APPENDIX 7: COMMENTS AND RESPONSES ON PROPOSED 2016 MONITORING NETWORK PLAN, REVISION 1

Re: 2016 Monitoring Network Plan, Revision 1 (November 15, 2016)

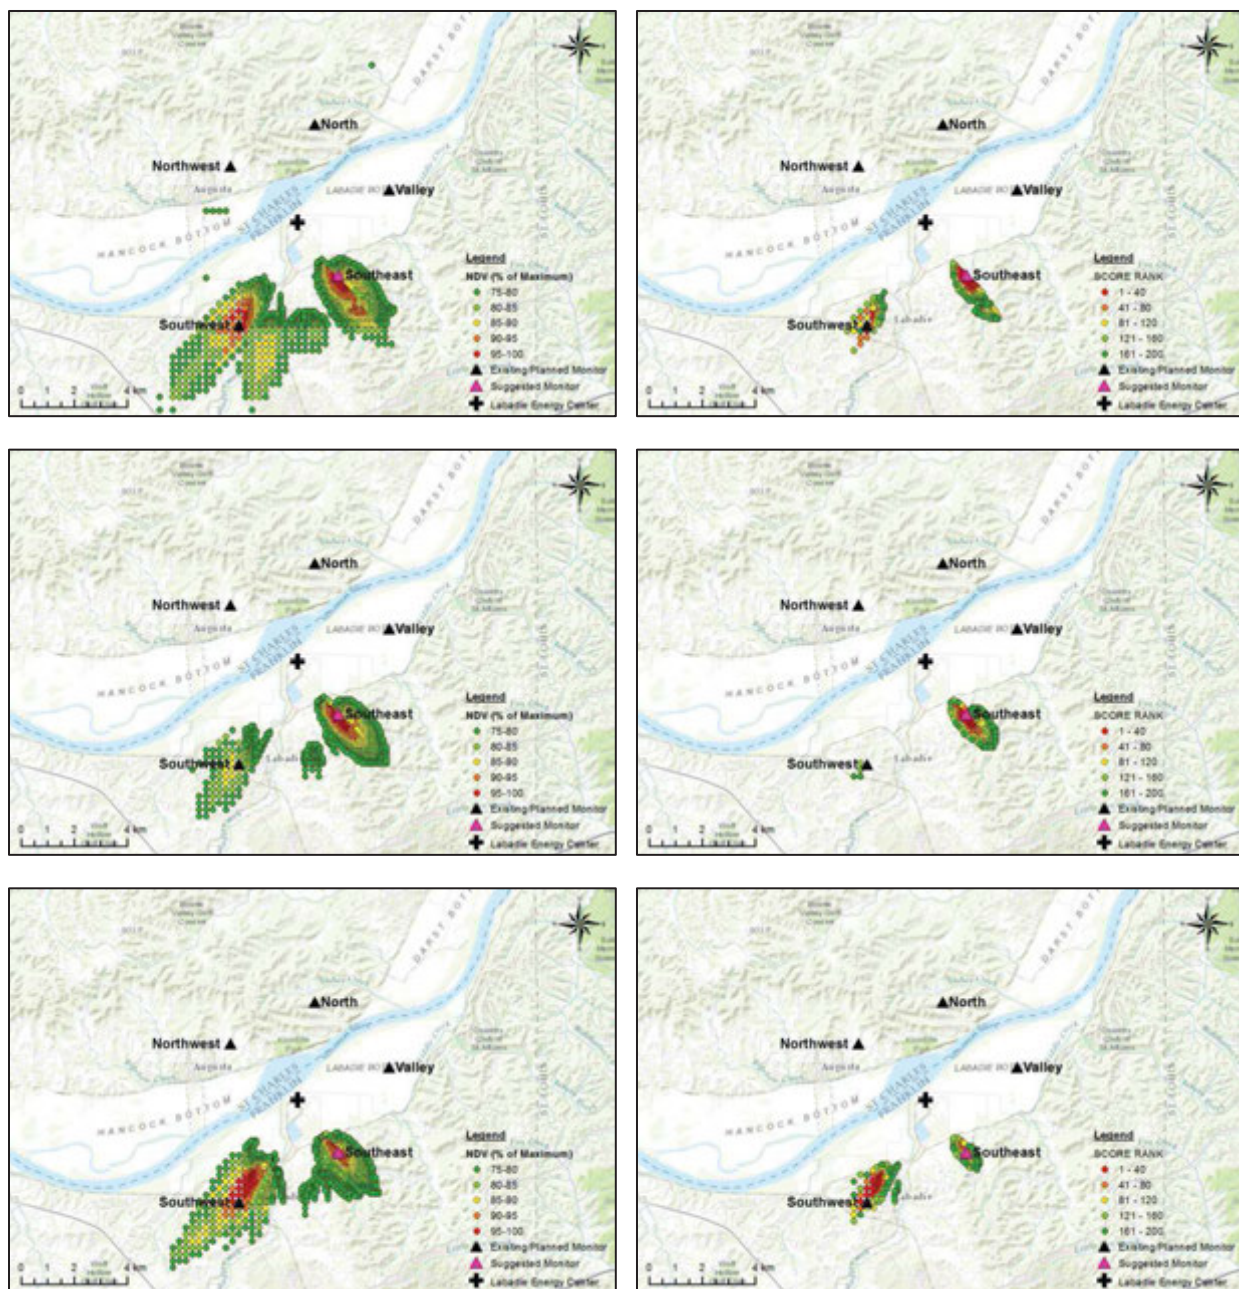
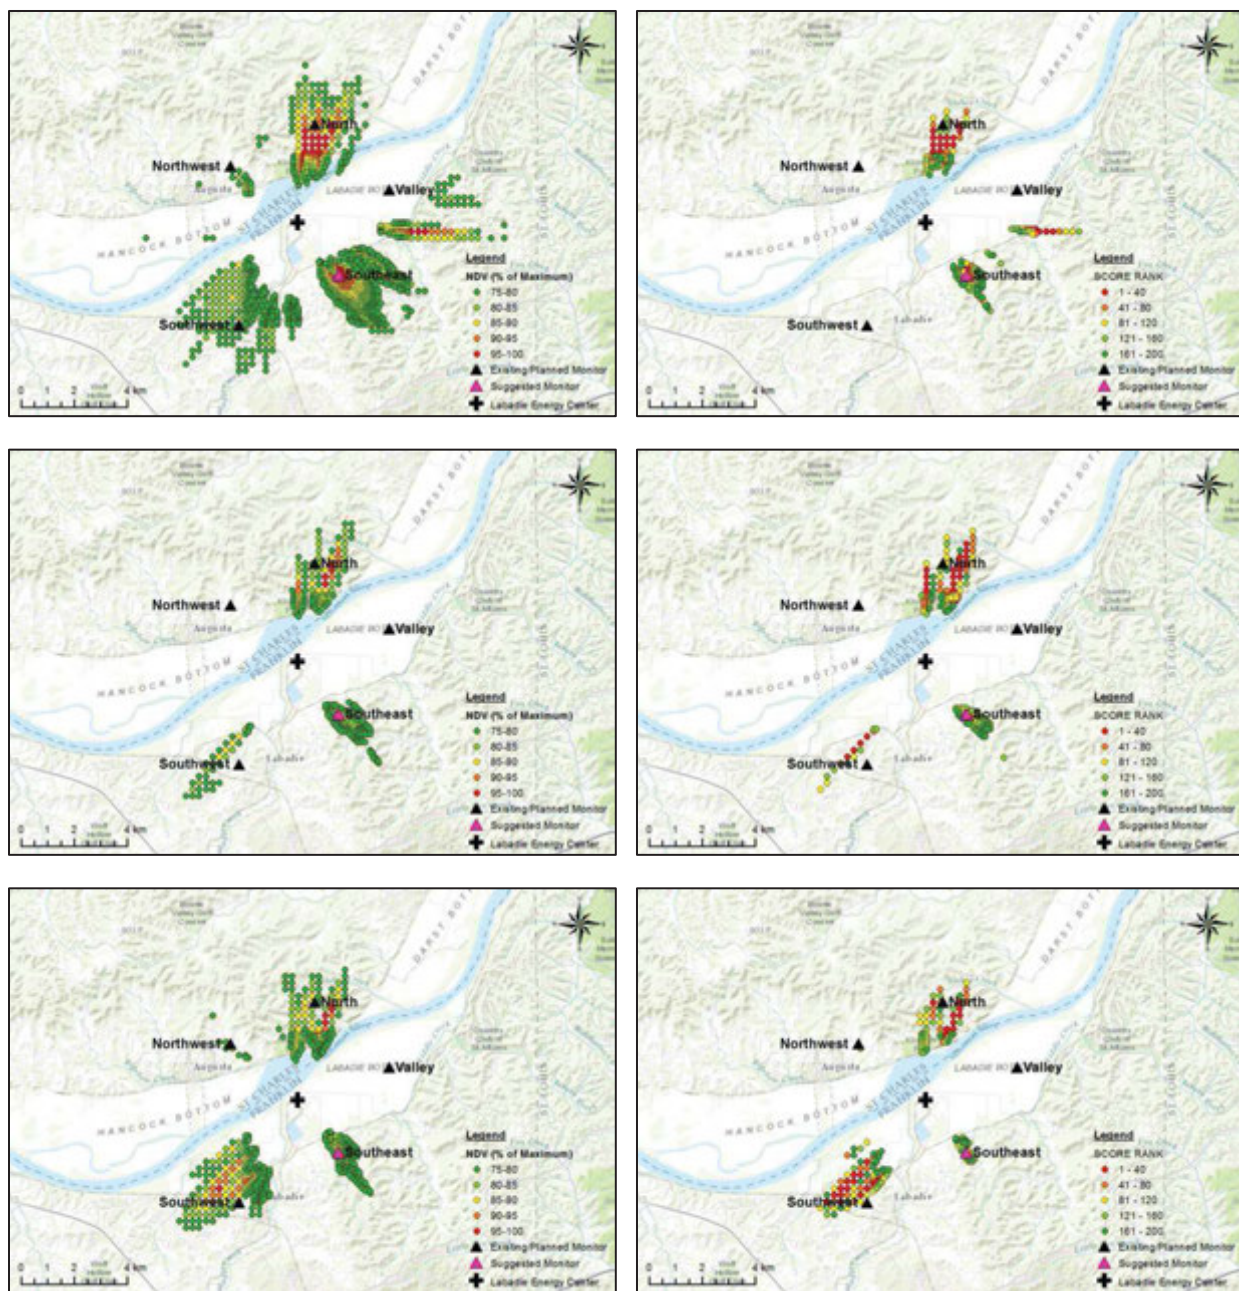
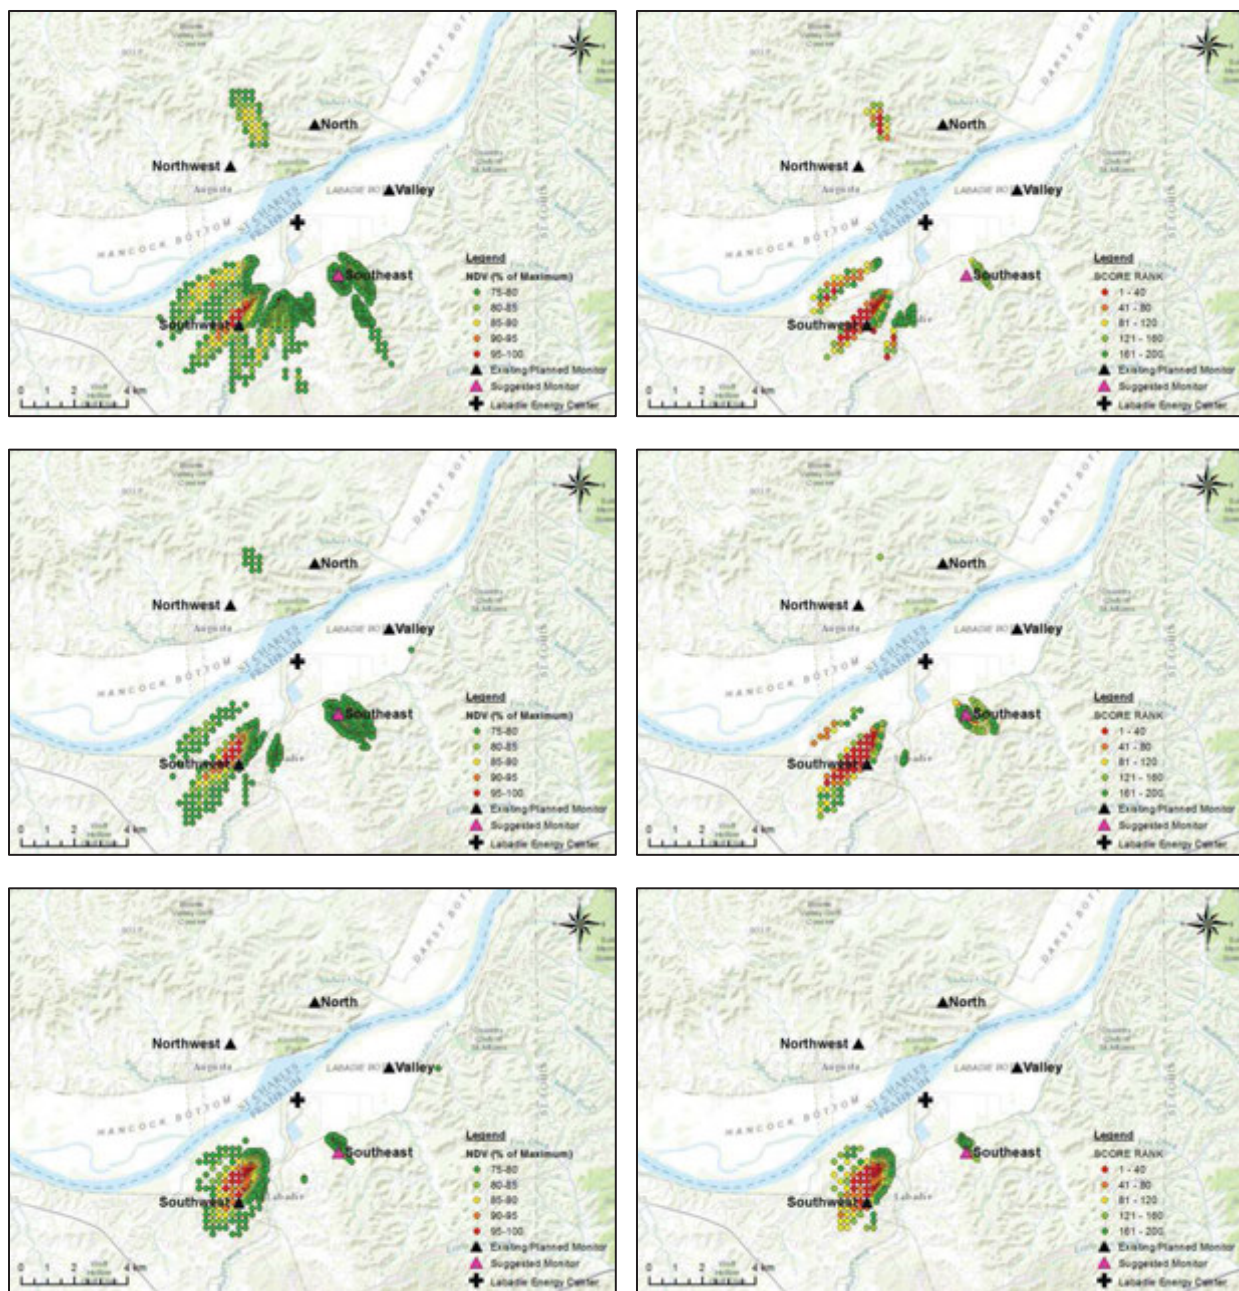
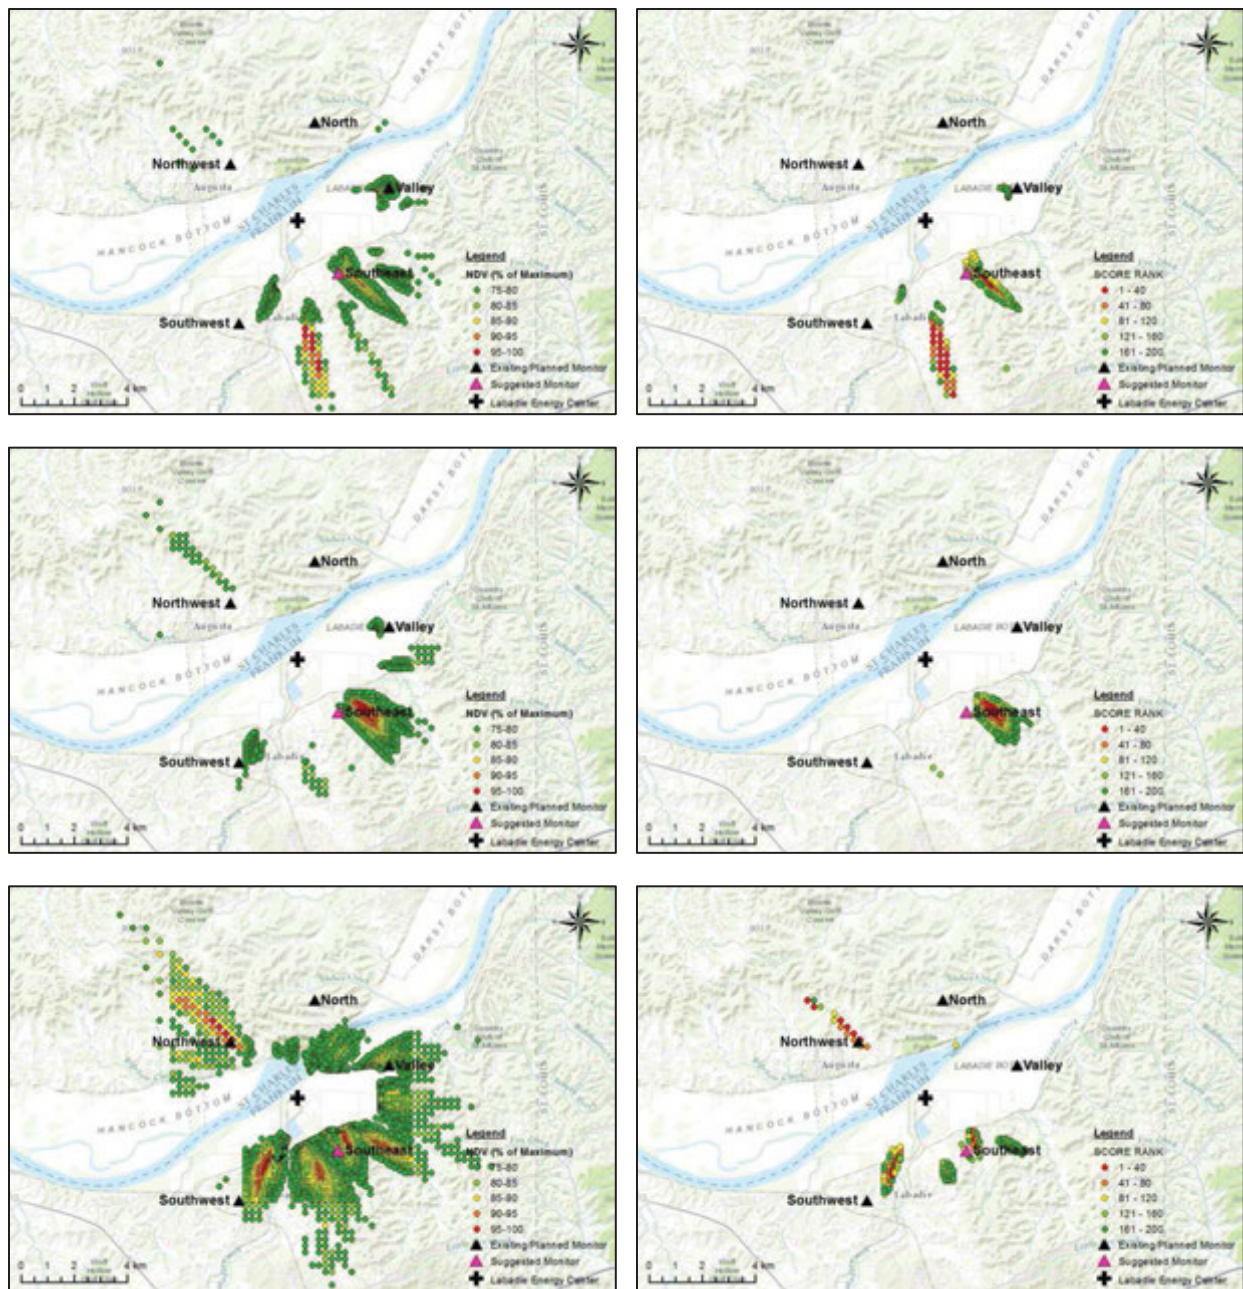
The results of Ameren's recent modeling are shown in Figures 1-4. These figures show normalized design values ("NDVs") for all receptors exceeding 75 percent of the maximum NDV and score ranks for the top 200 receptors for all meteorological and emissions datasets used in the modeling.⁵

As Figures 1-4 clearly demonstrate, all of Ameren's recent modeling shows an area of high NDVs and/or highly ranked receptors southeast of Labadie. The size and exact locus of the area, modeled NDVs, and receptor ranks all vary somewhat depending on the meteorological and emissions datasets used. However, in every instance there is a grouping of top 200 receptors in the area that frequently includes some of the most highly ranked receptors. Further, modeled NDVs in the area are always greater than 75 percent of the maximum NDV and are greater than 90 or 95 percent of the maximum in over half of the runs. Hence the modeling strongly supports a monitor southeast of the plant.

Figure 5. Summary average score rank over all met scenarios, actual hourly emissions scenario.

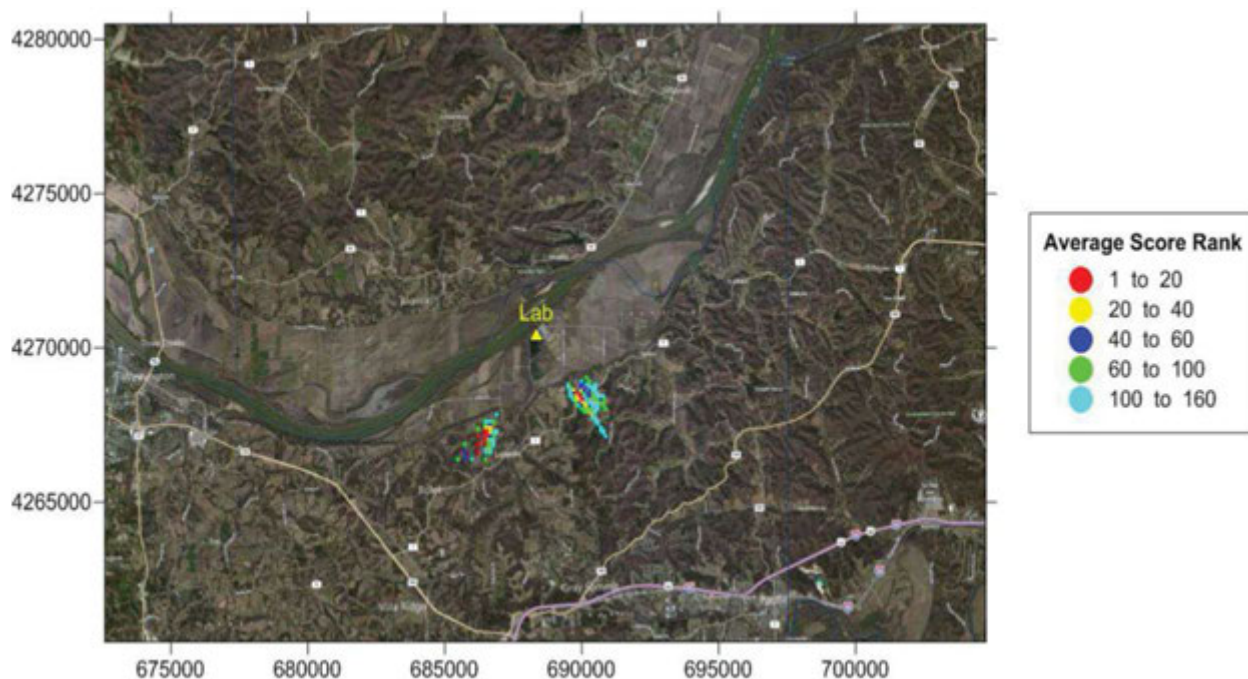
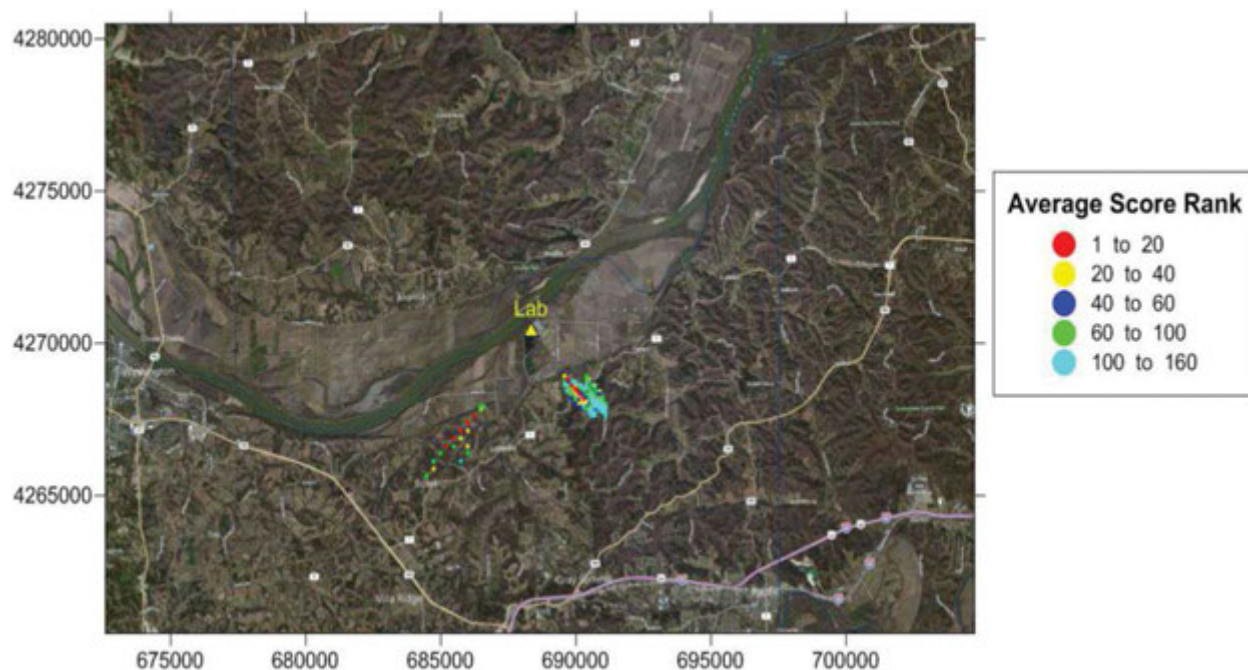
Figures 5 and 6 both show groupings of duplicate receptors with high average score ranks southeast and southwest of Labadie. This analysis provided Ameren's justification for the new Southwest monitor. However, it also clearly demonstrates the need for a monitor southeast of the plant, an area Ameren itself labeled a "preferred monitoring location" pursuant to its own analysis.⁸ The addition of a southeast monitor is critical to monitoring all significant areas around Labadie where peak 1-hour SO₂ concentrations are expected to occur. Our suggested location, shown in Figures 1-4, was chosen due to the high modeled concentrations in the area, the lack of obstructions and easy access to utilities, and because it is out of the floodplain in elevated terrain with better exposure to Labadie's emissions.
